This gallery shows some pictures of bad solderings - they should prevent you from making the same errors (feel free to add even more pictures here!)

From:
https://wiki.midibox.org/ - **MIDIbox**

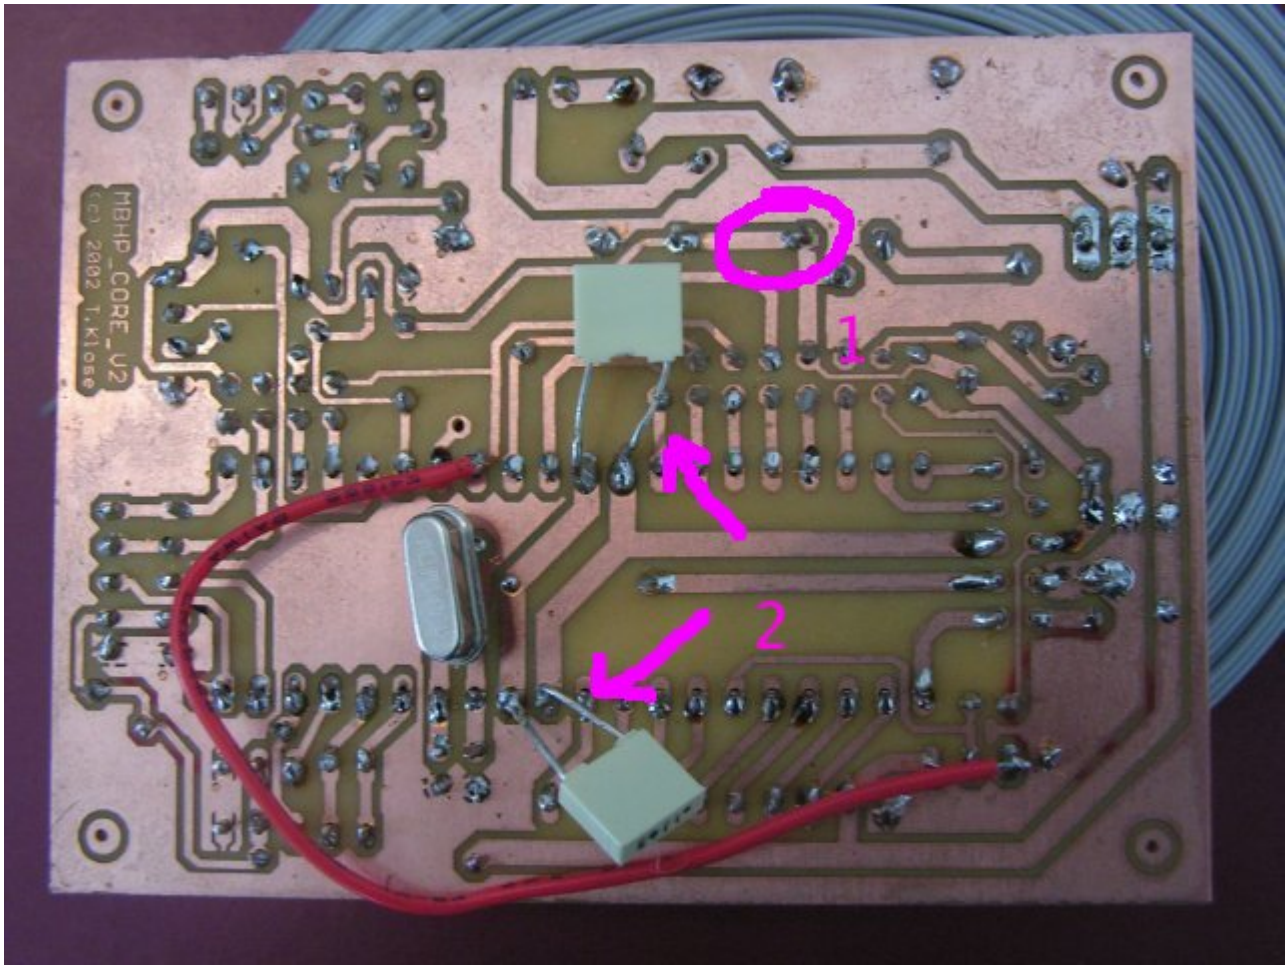
1: the core module has some bad solderings (loose connections), which could lead to failures. There are also missing solderings (e.g. 33pF cap below crystal). It makes sense to solder each pad again, the Soldering guide in the Wiki gives some useful tips
2: the legs of the caps should be cutted, otherwise they can cause a short circuit which can damage the PIC!

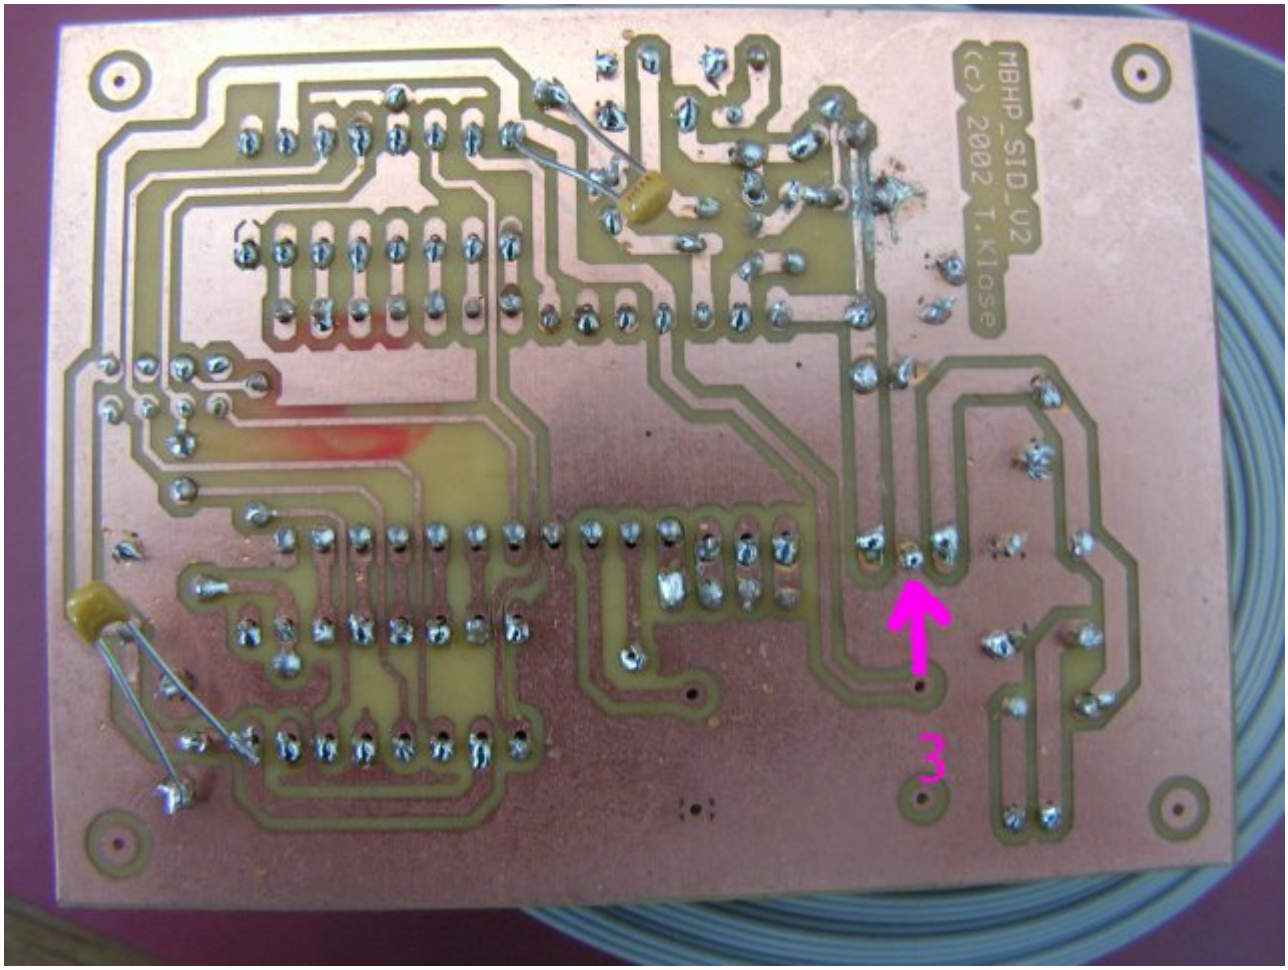
3: this seems to be a bad ground connection directly at the 78xx - it can lead to the wrong voltage. Here the same: just solder the pads again, it will help
And same like above: the long cap legs need to be cutted, the danger for shorts is too high!
